Service Bulletin #: AC-040709
Date: 7 April 2009
Models Affected: AS350, AS355, EC130
Compliance: REQUIRED FOR PROPER FREON SERVICING

This Service bulletin has been issued to any operator of Integrated Flight Systems air conditioning system installed on the following aircraft; Eurocopter AS350, AS355 & EC130.

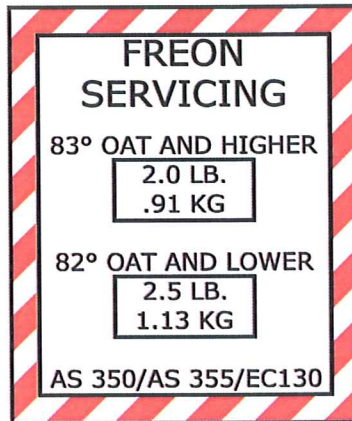
A placard has been made to show the proper amount of Freon required for servicing.

This new data shown in the placard reflects the latest info on servicing now being sent with our kits. Disregard any previous servicing instructions, and follow the placards data.

If sticker is needed please contact I.F.S. at 1-817-624-6600, order P/N: 120214.
